Item #7
9:30 AM
August 11, 2022

STAFF REPORT

RE: **Konocti Christian Academy; Major Use Permit (UP 21-52) and Initial Study (IS 21-54);** for development of a private K-9 grade school; located at 5805 Live Oak Drive, Kelseyville (APN: 008-061-72)

Figure 1. Site Plan

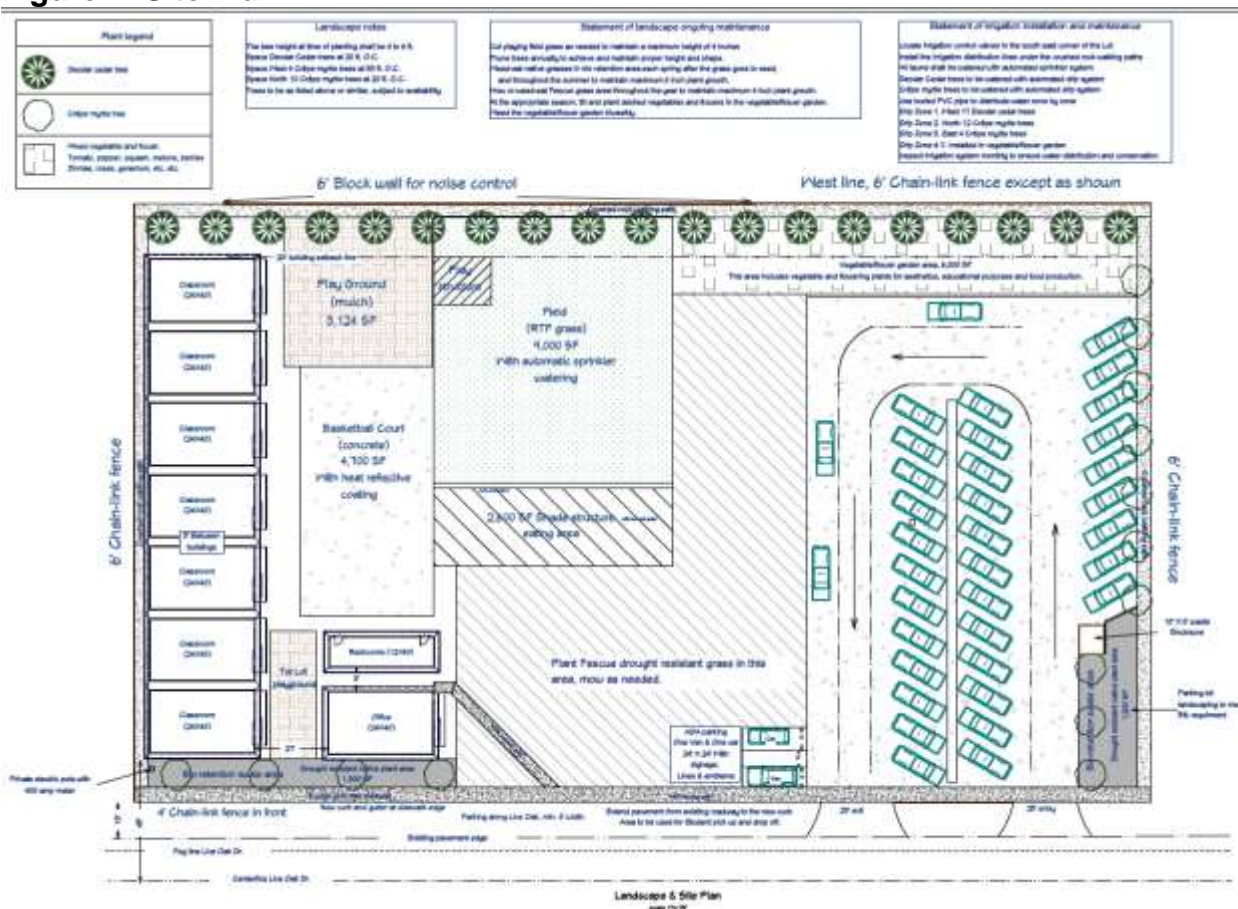
Response: *The applicant submitted the revised site and landscape plan, however no separation between vehicles and planted areas were shown, and shall be shown on a revised plan prior to any building permits being issued.*

Response: *The revised site plan received shows 33 parking spaces and two (2) ADA parking spaces, excluding the on-street parking that would be required by the County for pick-up and drop-off refuge areas along Live Oak. The applicant has stated that the school would employ up to 15 staff members, and would have up to 150 children. Based on these projected numbers of staff and children, the site should contain 33 parking spaces plus two (2) ADA-compliant spaces.*

Public Works Staff expressed concerns about the layout of the pick-up and drop off area, and because of the lack of shoulders or parking area along Live Oak Drive. Associate Engineer John Everett stated the following in an email dated February 10, 2022:

On June 8, 2022, the applicant submitted a Traffic Study, prepared by W-Trans LLC. This study only recommended a pedestrian path along Live Oak Drive. Public Works however has indicated that on-street parking is needed and that a bioswale needs to be installed to replace the existing bioswale along Live Oak that was incorrectly engineered. A condition of approval has been added requiring a five-foot (5') wide elevated sidewalk with gutters, and on-street parking space improvements along Live Oak Drive prior to final occupancy for the school. The improvements required shall meet Public Works design requirements for on-street parking. Engineered drawings will be required by Public Works, since the improvements will need to occur on a public road. An encroachment permit from Public Works is also required due to work that will occur on public land, along with an Engineering Inspection Agreement.

- **TRANS-1:** Prior to final occupancy, the applicant shall construct a 5' wide sidewalk, curb and gutter along the entire frontage, which will result in an 8' wide paved shoulder from the existing edge of pavement to the face of curb. Plans for the improvements to the public right-of-way shall be prepared by a licensed engineer. The back of sidewalk should be placed along the property boundary. The existing bioswale located along Live Oak Drive shall be relocated for drainage and runoff control. Engineered drawings for the bioswale may also be required at the discretion of the Public Works Director.
- **TRANS-2:** Prior to any work occurring in the public right of way, an Encroachment Permit is required. The Public Works Director shall review any needed work in the right-of-way prior to issuance of this Encroachment Permit, and an Engineering Inspection Agreement shall be required.
